工程指示 / 要求簡箋(E.I.)

工程指示編號：EI / 2201 / 20

工程名稱：亞皆老街中電

工程項目：佛沙窗 夾通位置鑽孔

DWG NO. : J852-SD-PW-6004 REV. : B

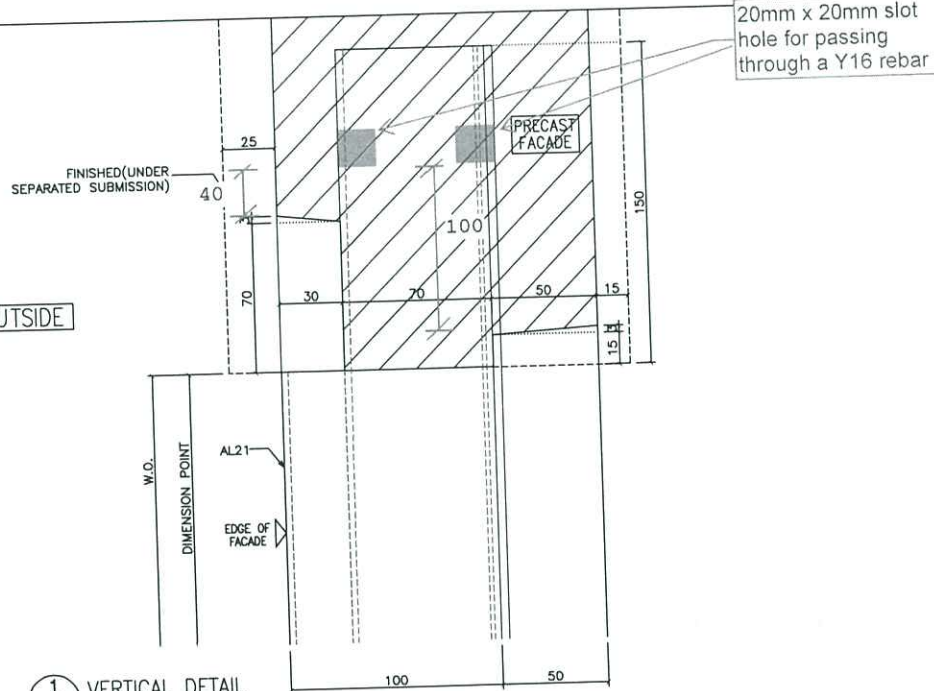
請按佛沙場和 RE 要求，因夾通加長後，會阻鋼筋。

因佛沙窗 EI 1971 和 EI 2091 已送佛沙場。請在佛沙場加開 20mm 圓孔。

20mm x 20mm slot hole for passing through a Y16 rebar

20mm x 20mm slot hole for passing through a Y16 rebar

窗洞 20x20 圓孔

DWG NO. : JB52-SD-PW-6008 REV. : -

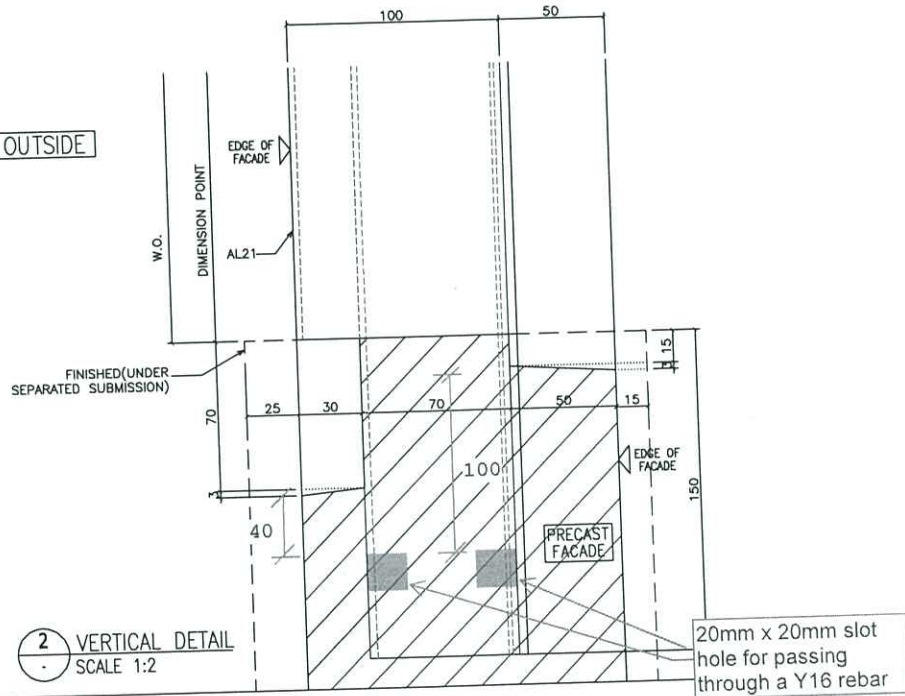
As discussed, we are queried by the MFT's RE that whether the additional 80mm intrusion of aluminum mullion will structurally affect the precast facade. After checking with our facade consultant, a 20mmx20mm slot hole would be required as per the attached markup in order to fulfill the structural calculation. Would you please check and advise whether it is feasible to form the slot holes before delivering the window to precast factory.
